HIGHWAY WORK PROPOSAL

<u>COUNTY</u>	<u>STATE PROJECT</u>	<u>FEDERAL</u>	<u>PROJECT DESCRIPTION</u>	<u>HIGHWAY</u>
Milwaukee	1360-00-76	N/A	W Fond Du Lac Avenue; 6 Highway Intersections	STH 145
Milwaukee	2595-03-73	WISC 2020073	N 60th Street; W Capitol Dr To W Hampton Ave	LOC STR

ADDENDUM REQUIRED ATTACHED AT BACK

Addendum No. 01
ID 2595-03-73
Revised Sheet 366
February 26, 2020

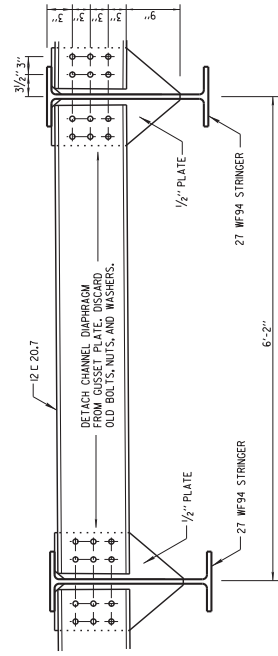
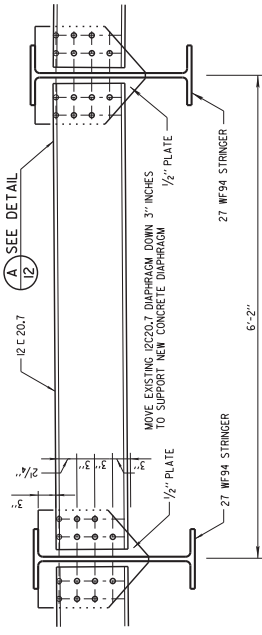
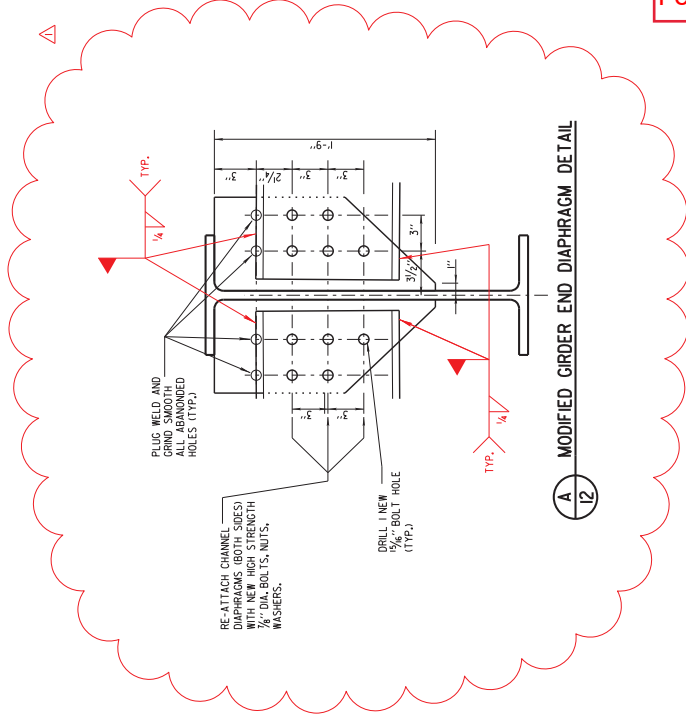
For the existing 12C20.7 steel channel girder end diaphragms; Drill one new ¹⁵/₁₆-inch diameter hole in the gusset plates 3 inches below the lowest pair of existing holes. Reposition the diaphragm 3 inches lower than its original orientation and reattach the 12C20.7 steel channel to the gusset plate by 5 bolts at each end. Augment the bolts by placing ¼-inch fillet welds along the sides of the channel section where it is adjacent to the gusset plate as shown in the plan. There are a total of 22 existing 12C20.7 steel channel girder end diaphragms to be adjusted. See plans for locations.

2/24/20	WELDING DETAIL ADDED	S.S.R.
NO.	DATE	REVISION
STATE OF WISCONSIN DEPARTMENT OF TRANSPORTATION		
STRUCTURE P-40-854		
DRAWN BY	PLANS M.P.F. CK'D.	A.R.
MODIFIED GIRDER END DIAPHRAGMS		SHEET 12 OF 23
		366

EXISTING GIRDER END DIAPHRAGM
BETWEEN GIRDERS (TYP.)

MODIFIED GIRDER END DIAPHRAGM
BETWEEN GIRDERS (TYP.)

Addendum No. 02
 ID 2595-03-73
 Revised Sheet 242
 March 2, 2020

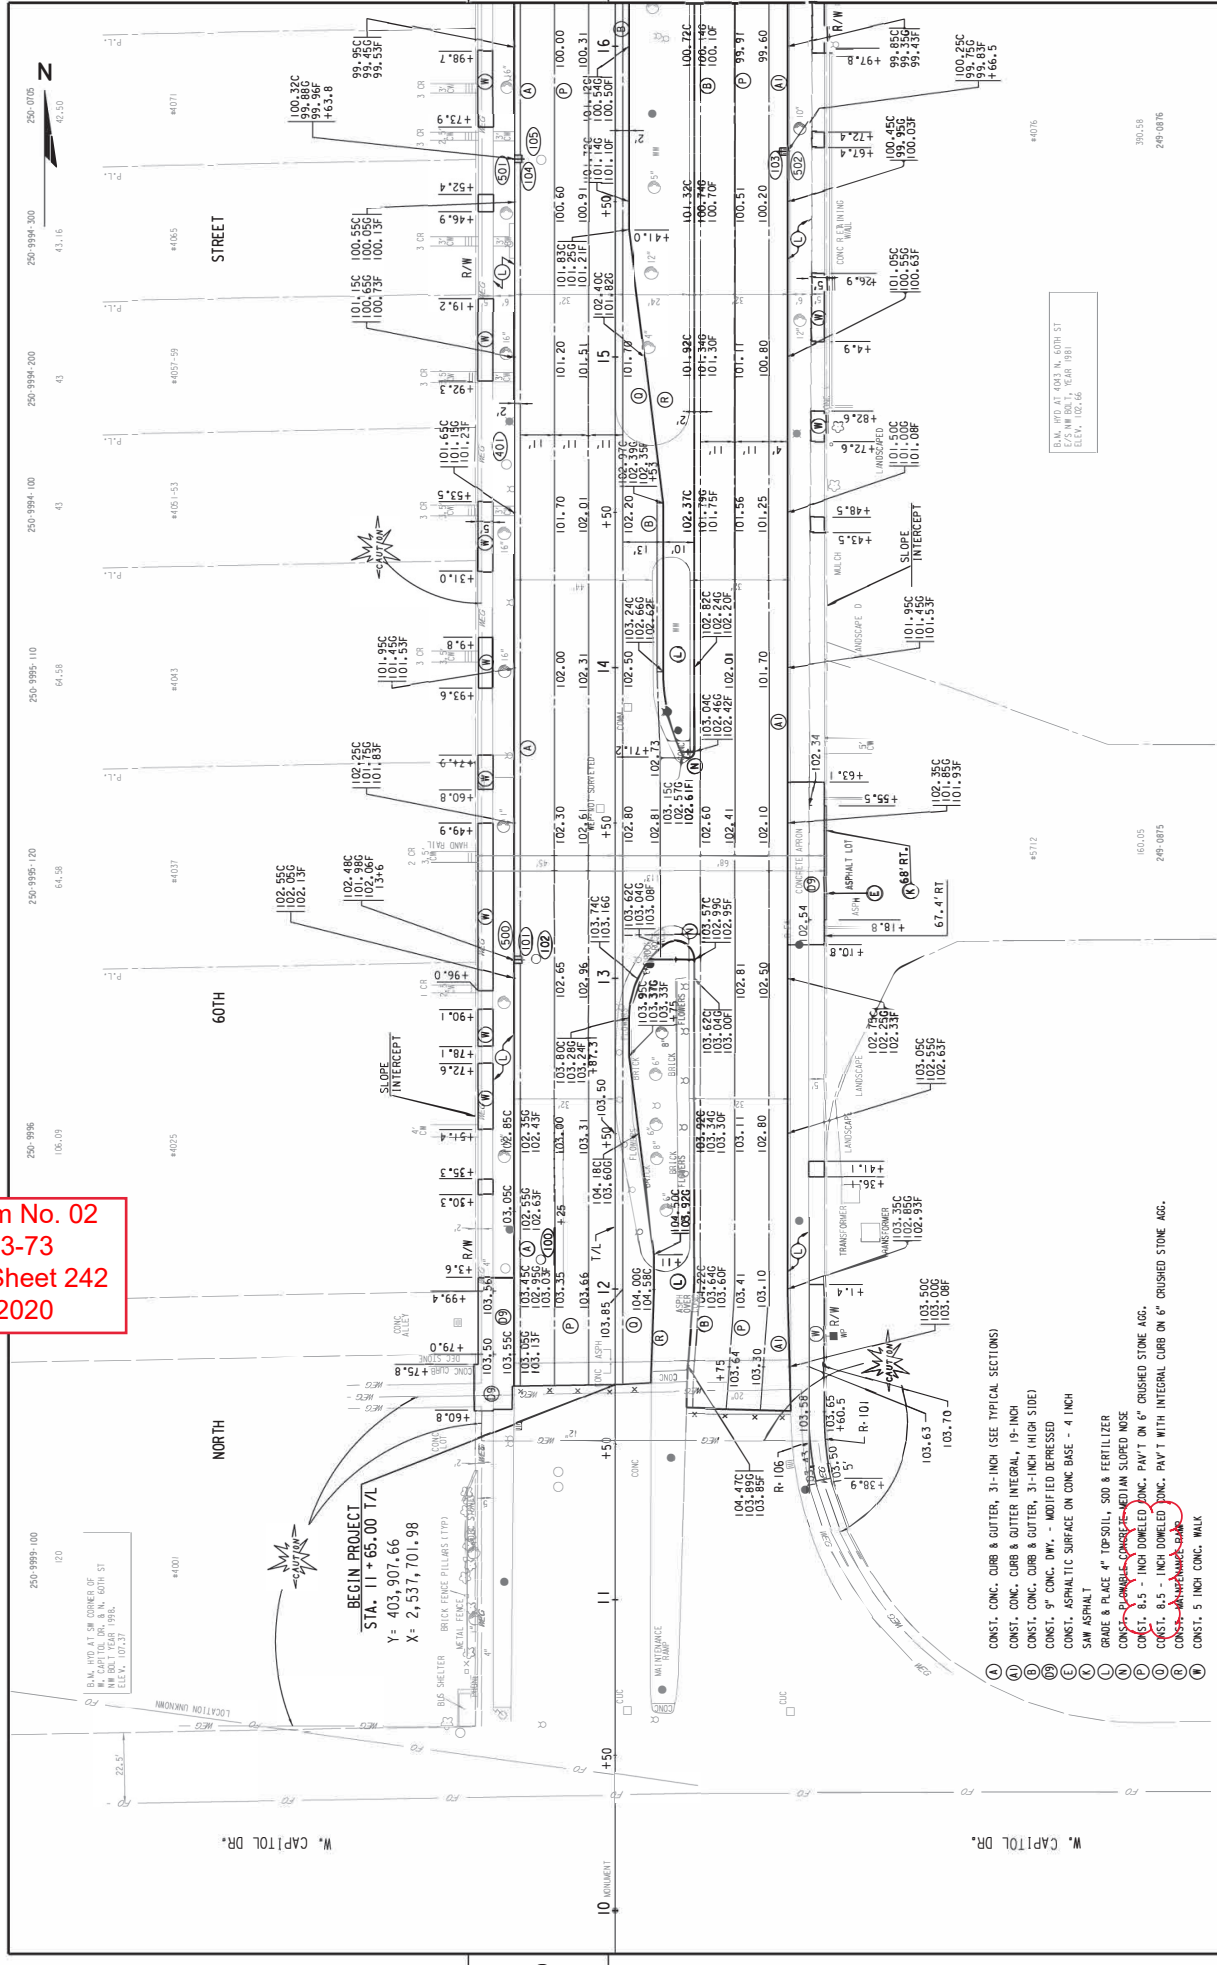
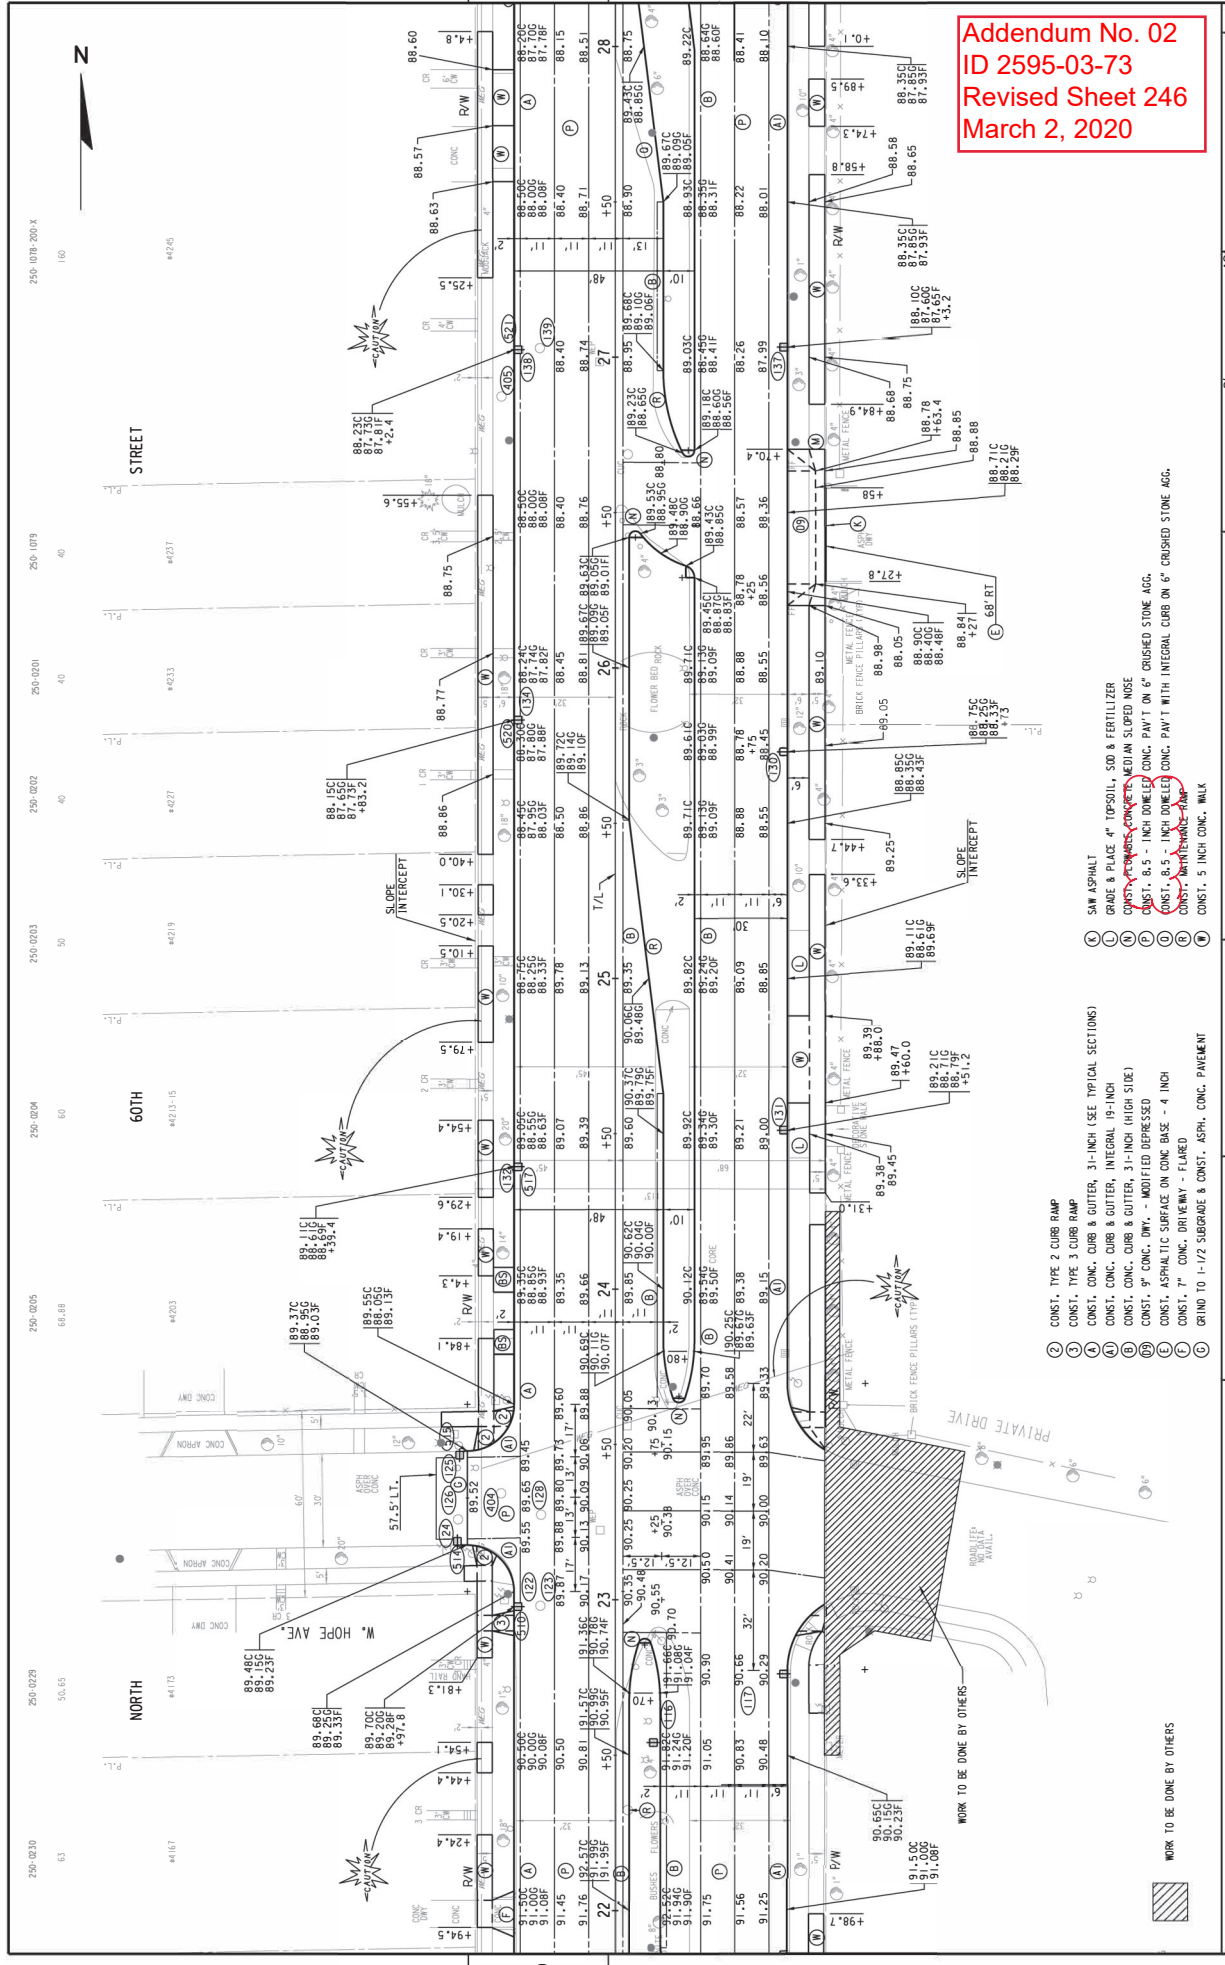
The following 8½ x 11-inch sheets are attached and made part of the plans for this proposal:
Revised: 242, 244, 246, 248, 250, 252, 254, 256, 258, 260
